TCEQ Interoffice Memorandum

SUBJECT: Granite Construction Company
WRTP 13817
CN600419063, RN111361143
Application No. 13817 for a Temporary Water Use Permit
Texas Water Code § 11.138, Requiring Limited Mailed Notice
Long Branch, Trinity River Basin
Ellis County

Removal of Water Plans

Chambers Creek Watershed | Floodwater Retarding Structure No. 10

Water Diversion Plan

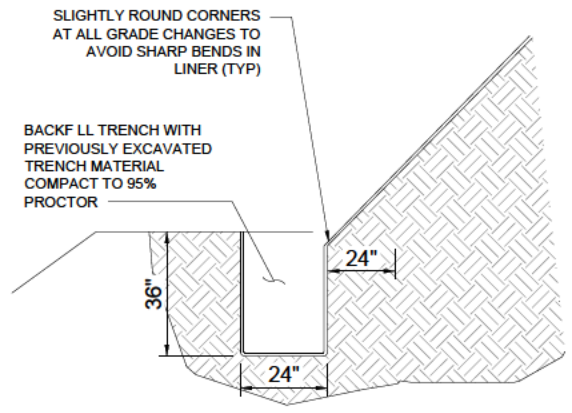
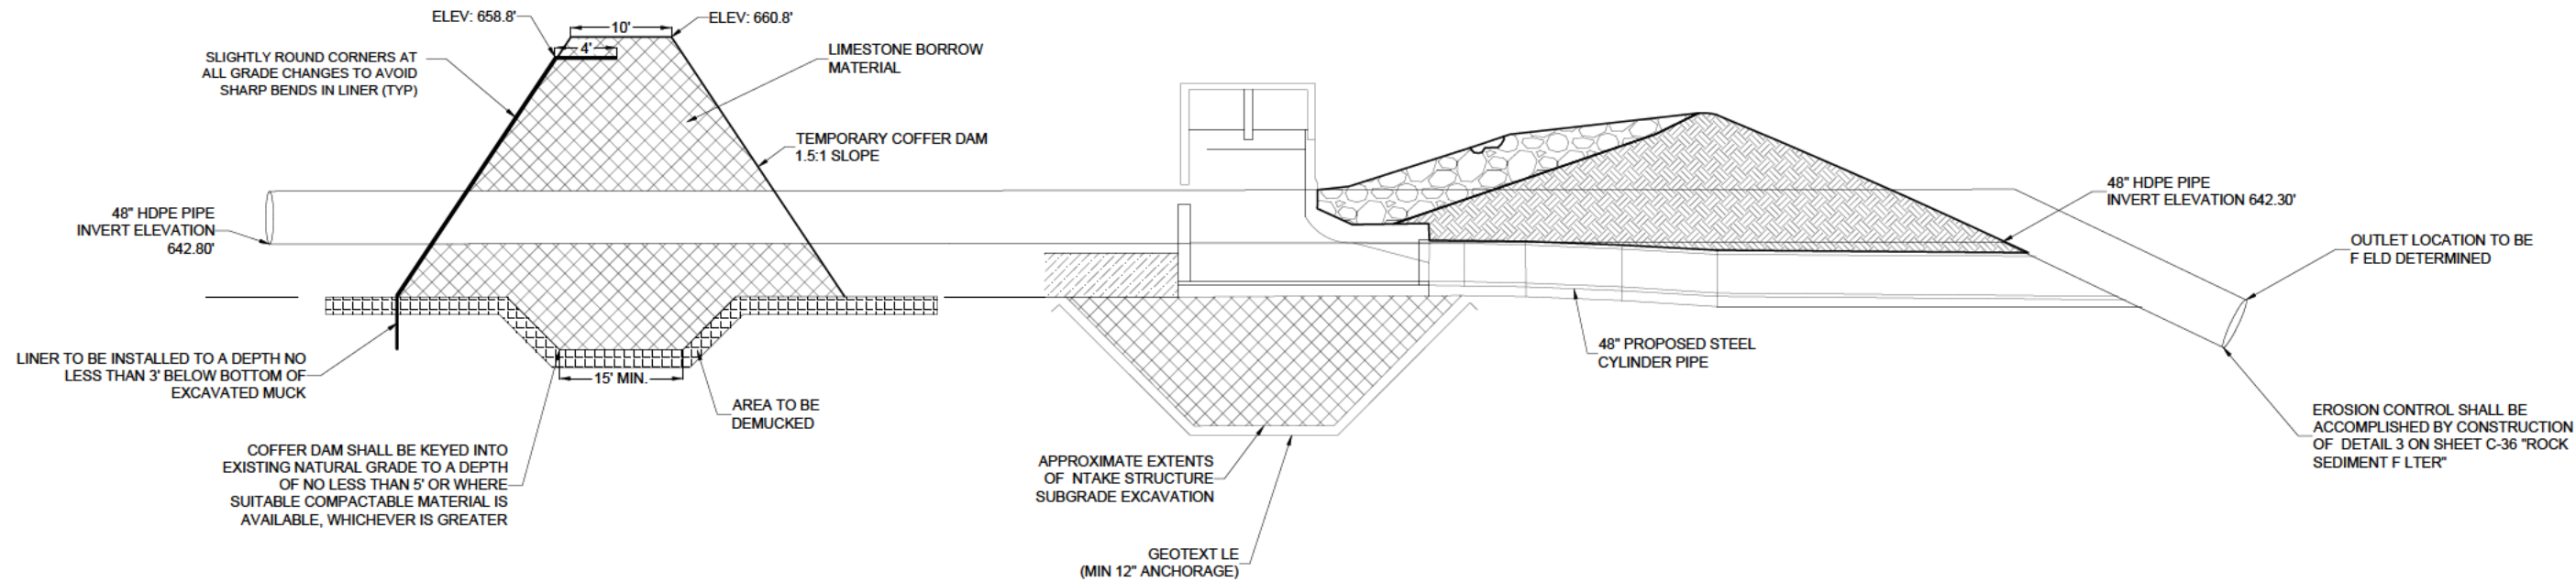
Number	By	Comment
1	USDA - NRCS	<p><u>Water Diversion Plan, Cofferdam Construction, Step 2:</u> This step discusses placing density controlled earthen fill only, and not the limestone as well; Also it only discusses compaction for earthen fill, without addressing the limestone material as well.</p> <p>ANS: Construction Specification 23 – Earthfill states, “Earthfill is composed of natural earth materials that can be placed and compacted by construction equipment operated in a conventional manner.” The density controlled earthen fill material mentioned in Step 2 is the limestone borrow material called out on Sheet 1 of 4 of the coffer dam detail exhibits. The limestone material will be compacted to 95% of the standard proctor density.</p>
2	USDA - NRCS	<p>Will placement and compaction meet the requirements of CS 23? If so this needs to be addressed?</p> <p>ANS: Yes, placement and compaction will meet the requirement of CS 23. The limestone material will be compacted to 95% of the standard proctor density and 0% to +3% optimum moisture. The contractor will utilize dozer rippers and/or excavator bucket teeth for moisture conditioning of the limestone material and scarification of lifts. A disk can not be used in these instances due to the use of limestone rock for coffer dam construction.</p>

3	USDA - NRCS	<p>How will water be sealed off around the pipe and kept from seeping through the cofferdam, if the 48” pipe will be puncturing the liner by going through the cofferdam?</p> <p>ANS: A boot (as shown below) will be used to seal the cofferdam where the 48” pipe penetrates the liner.</p>  <p>Illustration of pipe boot detail—A pipe boot was constructed from an additional piece of geomembrane liner.</p>
